Product Change Notice

PCN#: EE-PCN21022
10/21/2021

CLASSIFICATION OF CHANGE: Mechanical

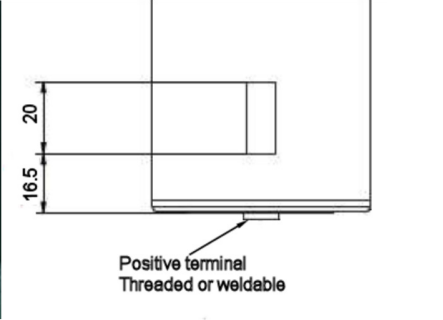
Removing the re-closable overpressure release VALVE in the terminal. ADD one-time notch vent on side of cell.

<p>Existing valve design. Pressure relief is in the center of the terminal.</p>	<p>New design: notch in sidewall of can.</p>

Valve design releases some gas during normal operation. This can be mistaken interpreted as a defective cell. The design eliminates this possibility.
